AMENDMENT NO. 2 NOVEMBER 1997
TO
IS 3075 (PART 1) : 1986 SPECIFICATION FOR CIRCLIPS
PART 1 FOR SHAFTS

(*First Revision*)

FIG. 2 BEND TEST AND FRACTURE TEST

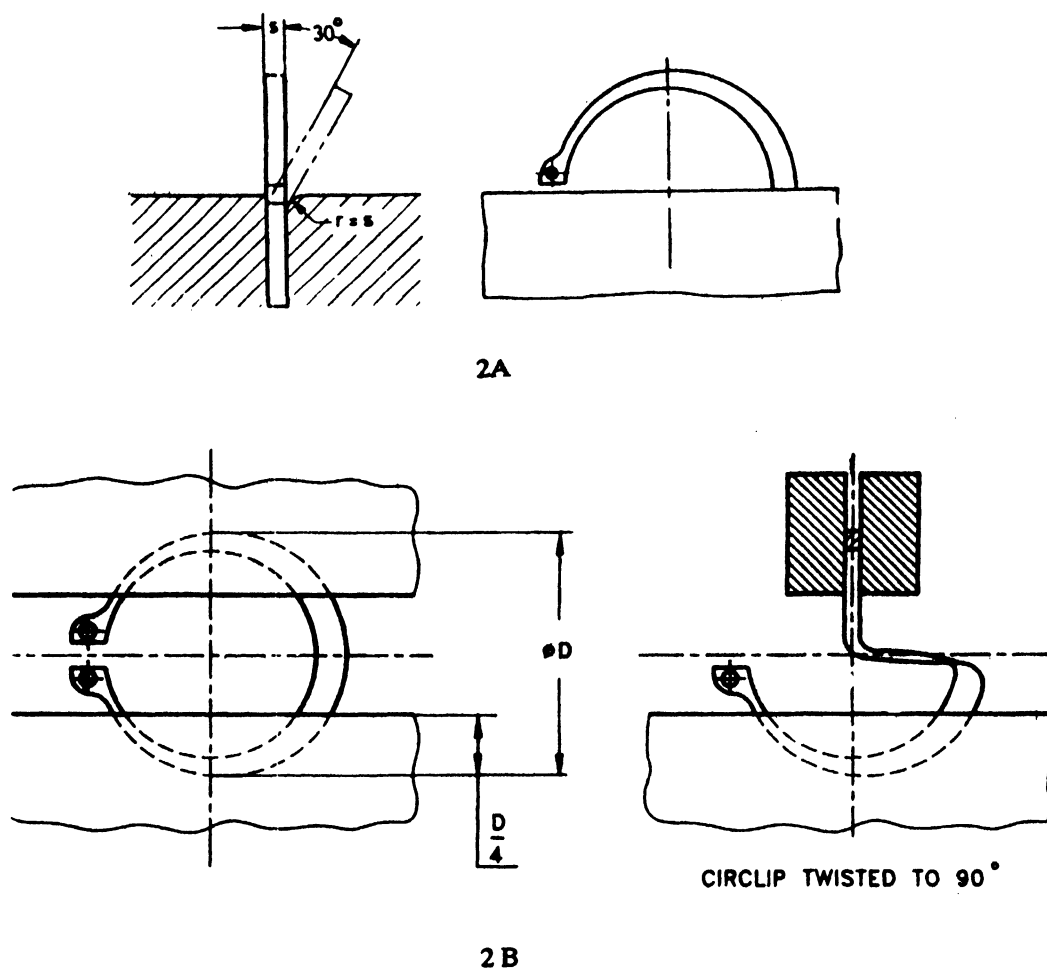
(*Pages 6 and 7, clauses 7.2 to 7.2.2*) — Substitute the following for the existing clauses:

The circlip shall be clamped between two jaws, of which one has a radius equal to the thickness of the circlip as shown in Figure 2A. The circlip is bent through 30° by repeated light hammer blows or with a lever, following which there shall be no fracture or cracks in the circlip. The circlip is then further bent until fracture occurs. The fracture surface shall reveal a fine-grained structure.

The circlip shall be clamped so that 3/4 of its diameter is free as shown in the Figure 2B. An equivalent section of the circlip shall be gripped and rotated through 90° following which there shall be no signs of fracture, cracks or similar defects. The circlips shall then be further twisted in the direction until fracture occurs, following which examination of the fracture shall reveal a uniform grain structure with no sign of lamination or other defects.

(Page 7, Fig. 2) — Delete.

7.2 Bend Test and Twist Test

7.2.1 Bend test

7.2.2 Twist test
